SUBJECT: ISSUANCE OF AMENDMENT FOR THE WASHINGTON PUBLIC POWER SUPPLY SYSTEM
NUCLEAR PROJECT NO. 2 (TAC NO. M93949)

AMENDMENT TO FACILITY OPERATING LICENSE

Amendment No. 145
License No. NPF-21

ATTACHMENT TO LICENSE AMENDMENT

CORE FLOW (% RATED)
Operating Region Limits of Specification 3.2.7
Figure 3.2.7-1

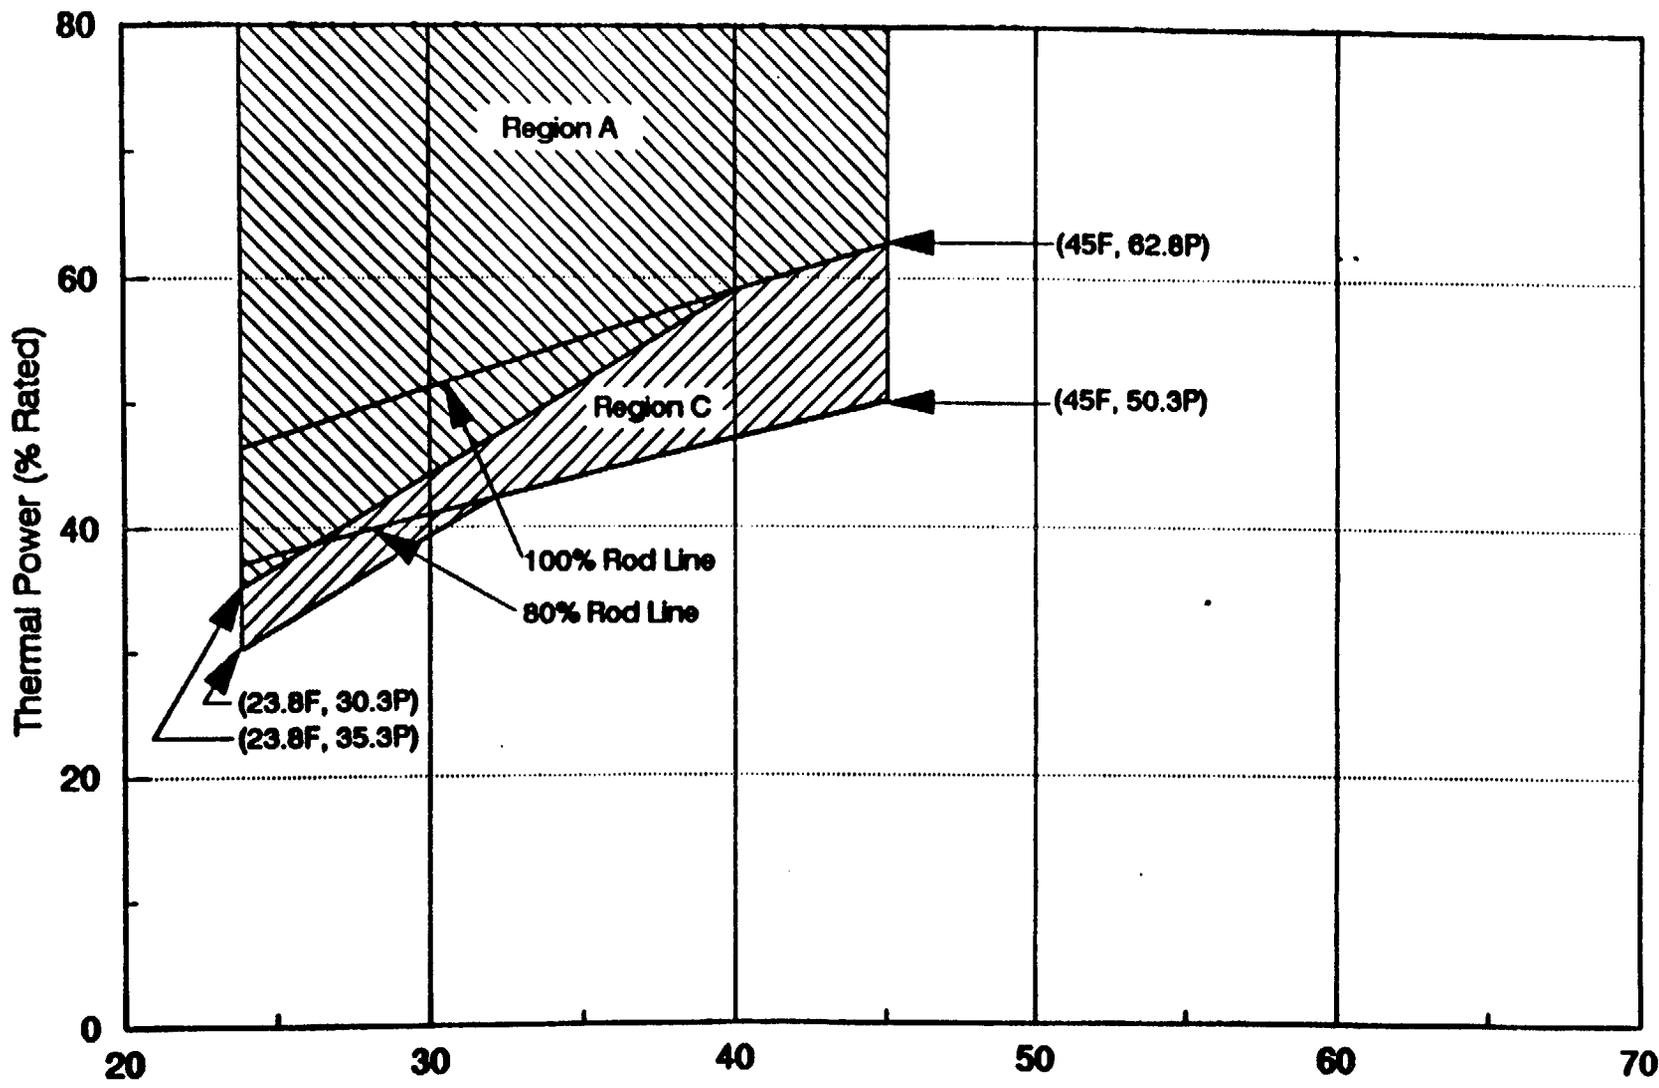
3.2.7 The stability monitoring system shall be operable* and the decay ratio of the neutron signals shall be less than .75 when operating in the region of APPLICABILITY.

APPLICABILITY: OPERATIONAL CONDITION 1, with two recirculation loops in operation and THERMAL POWER/core flow conditions which lay in Region C of Figure 3.2.7-1.

Core Flow (% RATED)
Operating Region Limits of Specification 3.2.8
Figure 3.2.8-1

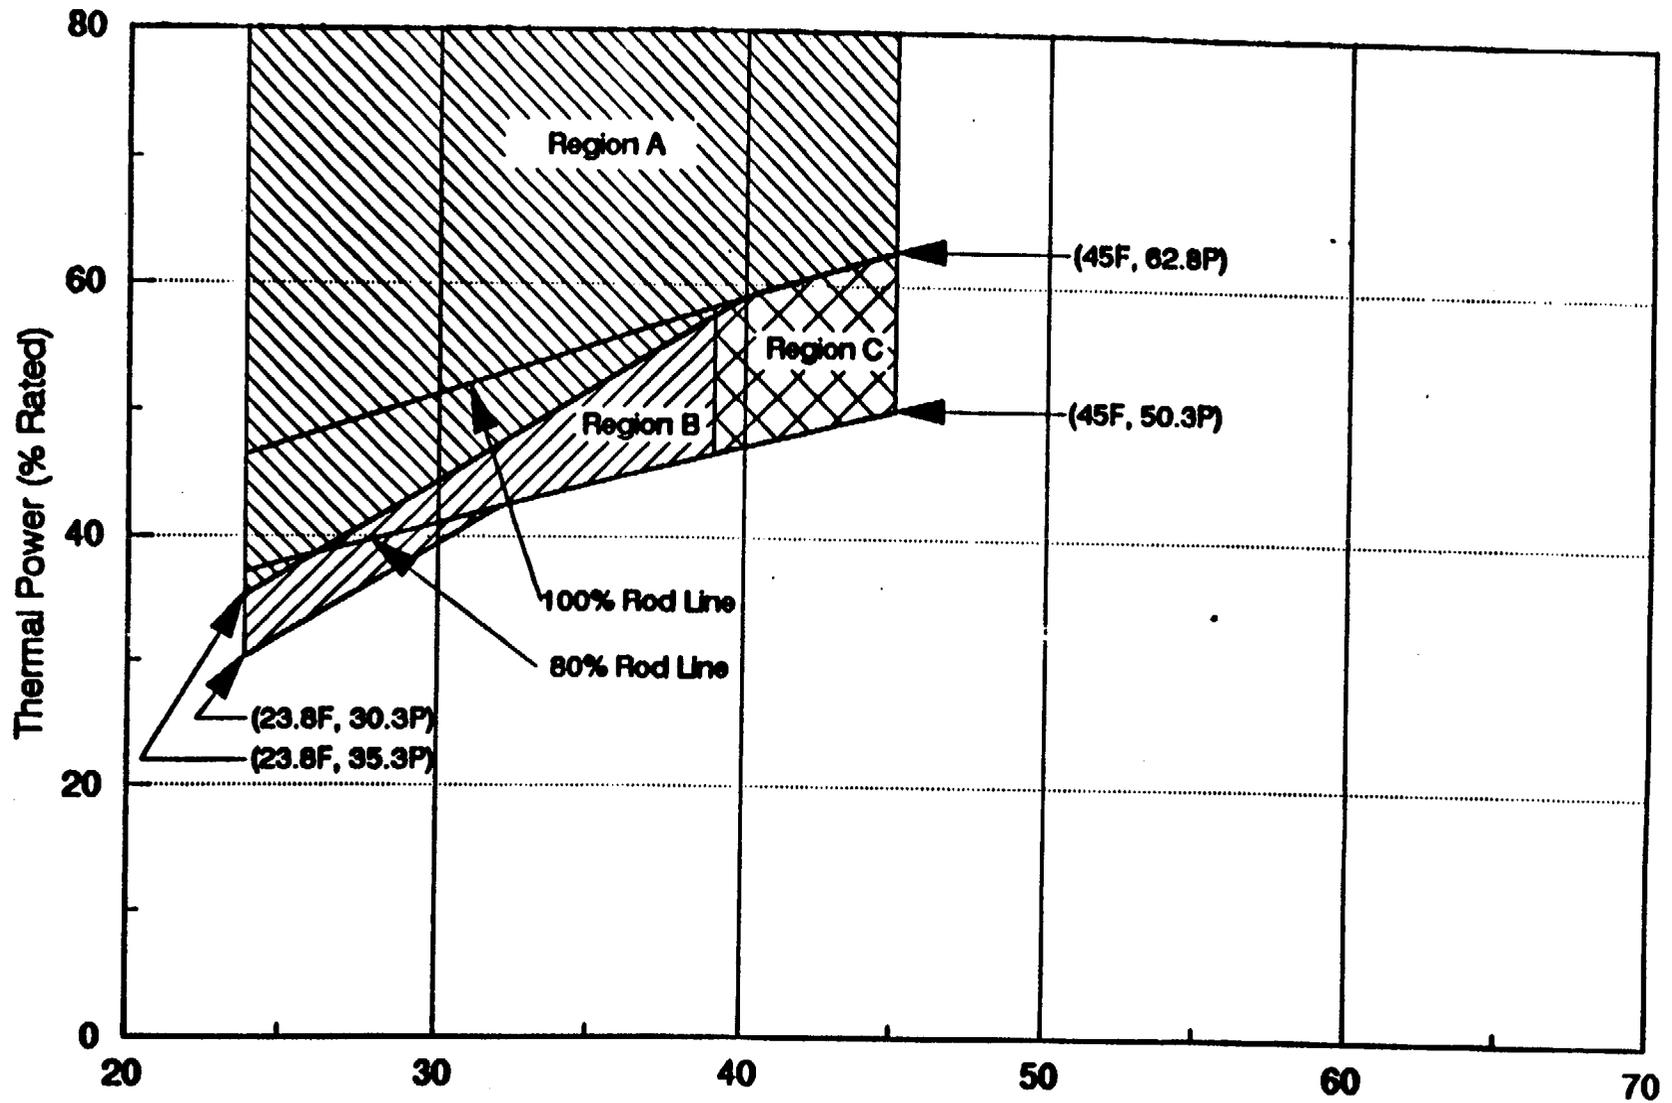
3.2.8 The stability monitoring system shall be operable* and the decay ratio of the neutron signals shall be less than .75 when operating in the region of APPLICABILITY.

APPLICABILITY: OPERATIONAL CONDITION 1, with one recirculation loop in operation and THERMAL POWER/core flow conditions which lay in Region C of Figure 3.2.8-1.

Core Flow (%Rated)
OPERATING REGION LIMITS OF SPECIFICATION 3.4.1.1
FIGURE 3.4.1.1-1

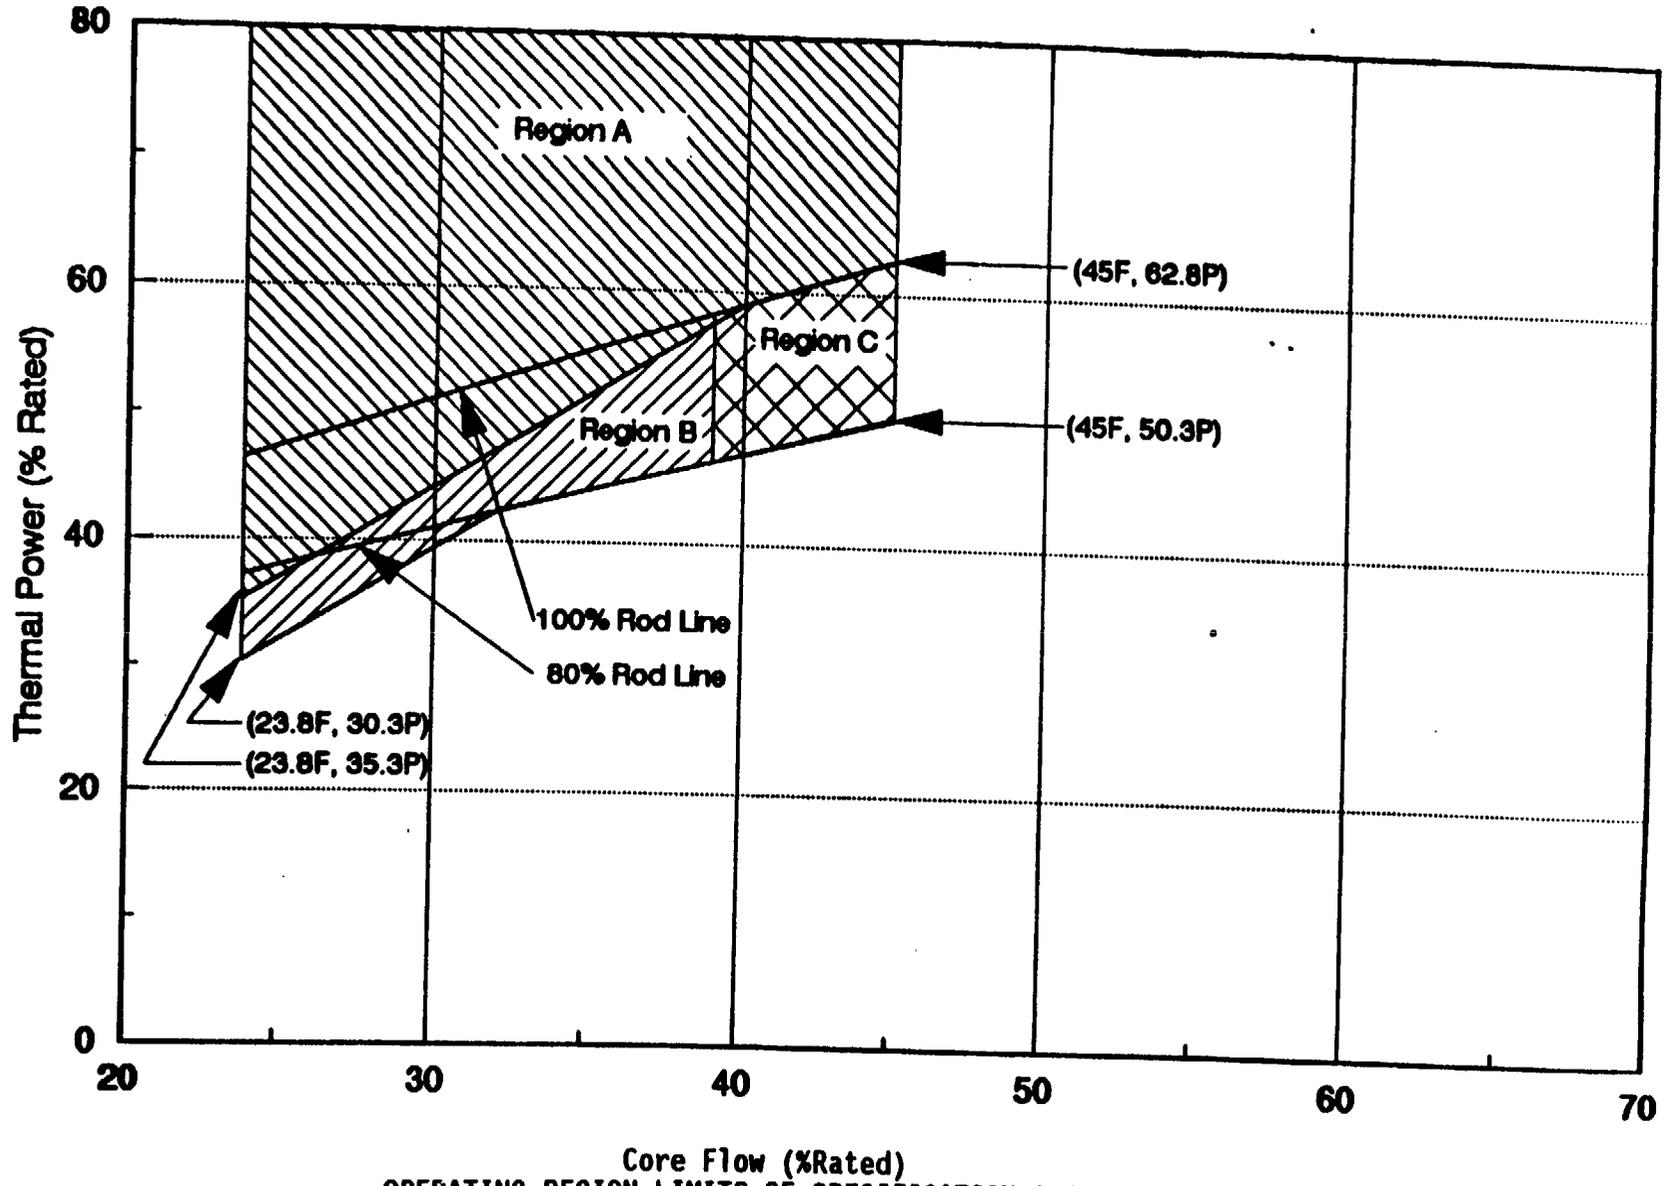
1. Verify that the requirements of LCO 3.2.6 and LCO 3.2.8 are met, or comply with the associated ACTION statements.
2. Verify that THERMAL POWER/core flow conditions lay outside Region B of Figure 3.4.1.1-1.

With THERMAL POWER/core flow conditions which lay in Region B of Figure 3.4.1.1-1, as soon as practical, but in all cases within 15 minutes, initiate action to exit Region B by either decreasing THERMAL POWER with control rod insertion or increasing core flow. Within 1 hour exit Region B. The starting of a recirculation pump for the purpose of exiting Region B is specifically prohibited.

- c. Core flow is greater than or equal to 39% of rated core flow when core THERMAL POWER is greater than the limit specified in Figure 3.4.1.1-1.
